**QUESTIONS AND RESPONSES TO THE:
REQUEST FOR PROPOSALS
ENTERTAINMENT VENUE AND EVENT CENTER AT THE BANKS
THE REDEVELOPMENT OF OHIO'S SOUTHERN GATEWAY
CINCINNATI, OHIO
MARCH 8, 2018**

As of March 1, 2018, the deadline for all written questions by interested venue developers, 17 questions had been submitted for response. Set forth below is the JBSC/City of Cincinnati/Hamilton County responses to the questions submitted.

EXHIBIT A

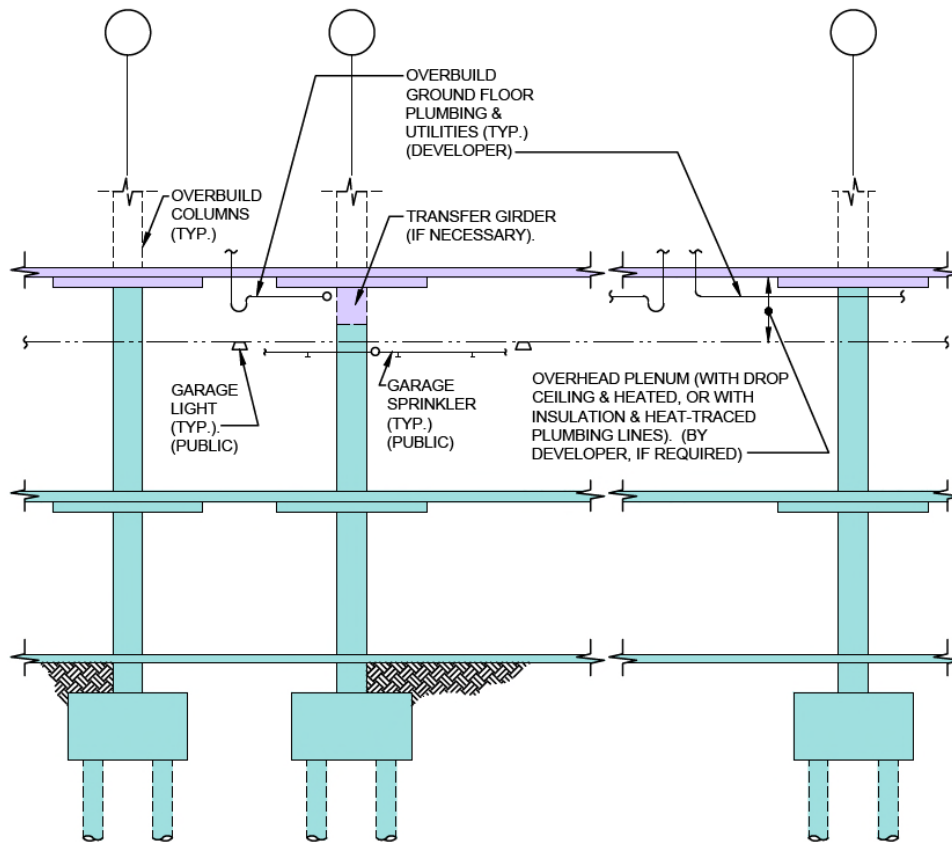
1. Please confirm the Banks Garage/Podium will be provided by the county. Please also confirm the county will include all supporting infrastructure under this slab, such as painting, signage, lighting, fire protection, ventilation, plumbing, etc.

2. We are presuming that the garage & podium include the top/transfer slab. Please confirm.

ANSWER: Hamilton County and the City of Cincinnati (the "Public Parties") will fund, design and construct the Public Parking Facility that will provide structural support for the proposed Banks Entertainment Venue. The Public Parking Facility shall be designed and constructed by the Public Parties which shall include the deep foundations, slab on grade, structural decks, ramps, primary public access drives (including those from the Podium Structure) columns, striping, signage, ventilation, fire suppression systems, flood control systems, security, lighting, elevator access to public rights of way, stairwells to public rights of way, headhouses at street level, walkways and mechanical, electrical and plumbing or similar systems. The Public Parking Facility shall include all architectural, structural, and MEP elements that serve and are required for a complete and fully operational parking facility. It is anticipated that the "Podium Structure" (including slabs, beams, any transfer girders, etc), which forms the 'lid' of the Public Parking Facility and the base for the Banks Entertainment Venue (See Exhibit A attached hereto), shall be:

1. Designed by the Public Parking Facility team in close coordination with and per the requirements of the Banks Entertainment Venue team.
2. Constructed by the Public Parking Facility team, since (a) it is integrally connected to the concrete garage structure, and (b) to expedite completion of the Public Parking Facility, as well as commencement of the Banks Entertainment Venue above.

3. Owned and maintained by the Banks Entertainment Venue, and
4. Paid for by the Banks Entertainment Venue.

The Podium Structure shall be designed as a 3-Hour horizontal separation between the Public Parking Facility and the Banks Entertainment Venue.

The Podium Structure shall be constructed within the Air Lot above the Public Parking Facility and shall be considered part of the Banks Entertainment Venue. All related waterproofing systems, drainage systems, expansion joints, finishes, heated plenum spaces or insulation and heat traced plumbing lines, private service branch utilities and other elements as generally depicted on Exhibit A attached hereto are the responsibility of the Banks Entertainment Venue Developer.

ANSWER: The Developer will be responsible for paying for the costs of the Podium Structure and all related components associated with The Banks Entertainment Venue (see response to question #1 above also).
